PRE-BID CLARIFICATION FORM

PROJECT NAME:		FILLMORE HIGH SCHOOL NEW ATHLETIC COMPLEX	
PROJECT NUMBER:		Project No. 2024-017 / DSA #03-123950	
TO:		RJ Stump EMAIL: rj.stump@fillmoreusd.org Fillmore Unified School Dist. Roy Frey WestGroup Designs royf@westgroupdesigns.com	
DATE:	January 29, 2025		
FROM:	Icon West, Inc. 520 S. La Fayette Park Pl, Suite 503 Los Angeles, CA 90057	EMAIL:	felix@icon-west.com
DOCUMENT/DIVISION NUMBER:	Spec 03-123950_SPC_A - Base Bid	DRAWING NUMBER:

REQUESTED CLARIFICATION: #14

LOW ROOF FRAMING PLAN

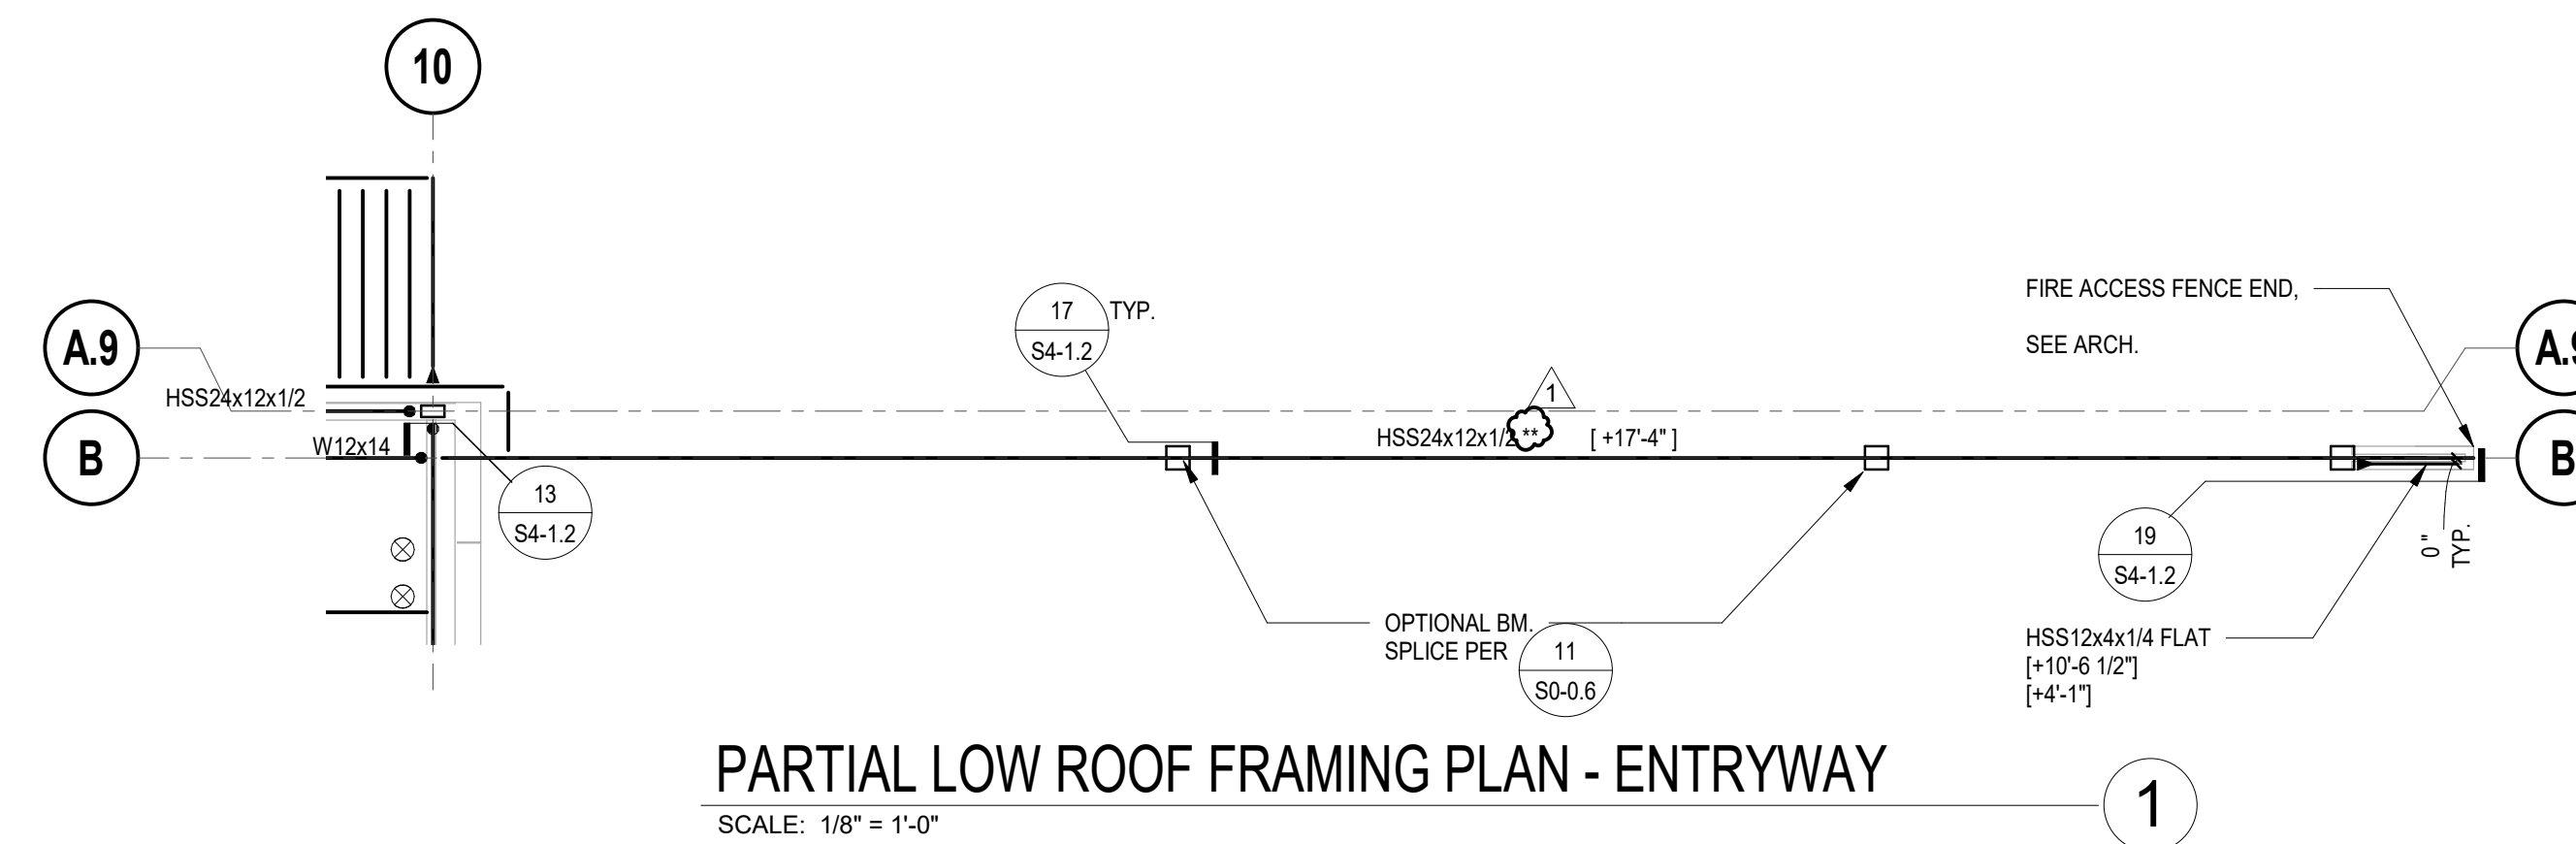
Sheet 89 of 788, 05 12 13 Architecturally Exposed Structural Steel. Please note that per the AISC, it is required that steel designated as AESS must be clearly marked on the plans (A and/or S drawings). We do not see any callouts for exposed structural steel or "AESS" on the architectural drawings nor the structural drawings. Please clearly identify what steel should be treated as AESS for level bidding purposes across all contractors bidding on this opportunity. Furthermore, please identify the AESS designation as required.

AESS marked on structural plans. Level to be AESS 3. See revised drawings.
